**TOWN OF ERIE
PLANNING COMMISSION MEETING
April 3, 2019**

SUBJECT: Spring Hill Sketch Plan - A Sketch Plan represents a generalized land use plan and layout for the area proposed to be included within a subdivision. A Sketch Plan application is required to allow for an early, informal evaluation of a proposed subdivision before detailed planning and engineering work has occurred.

PURPOSE: Planning Commission review and comment on a Sketch Plan application for of 632 lots and 33 tracts as well as right of way, parks, and open space.

Town of Erie Comprehensive Plan:

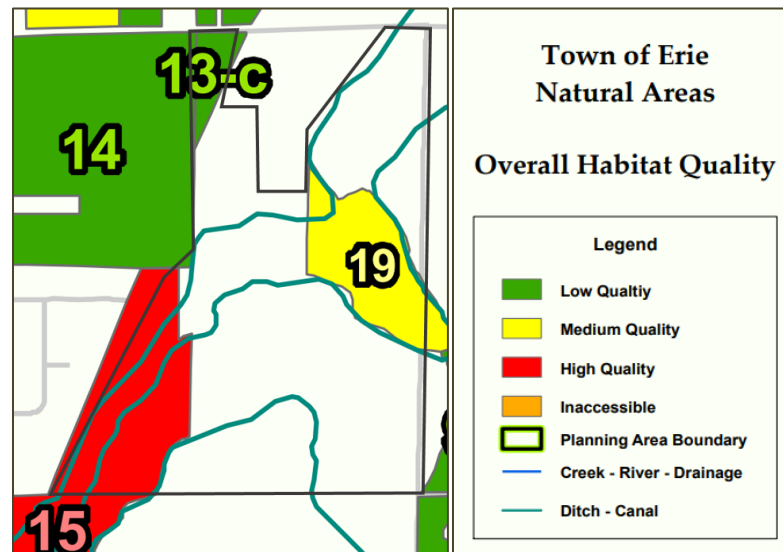
The proposed plan does not align with the Comprehensive Plan Land Use designation for this property. The approximately 70 acre area south and west of the Cottonwood Extension ditch is shown as Agriculture on the Comprehensive Plan. According to the Comprehensive Plan farming, ranching, and other agriculturally related uses and very low density rural residential uses are appropriate in this area. Also, lands designated Agriculture “serve a vital role in defining the history and character of Erie and should be maintained where viable, to serve as gateways and buffers, preserve vistas, and retain the desired character of the Town.” Within this area the sketch plan shows the western edge, the areas adjacent to the western two ditches (Lower Boulder Ditch and the Boulder/Weld Ditch), as open space and develops the remainder at a density consistent with an LDR land use designation. The LR Zone Designation (which defines allowed uses and development standards for those uses) does not negate the need for the subdivision plan to be consistent with the Comprehensive Plan. A Comprehensive Plan amendment allowing the change in Land Use designation from this area would be required to be approved for this subdivision plan to conform to the Comprehensive Plan.
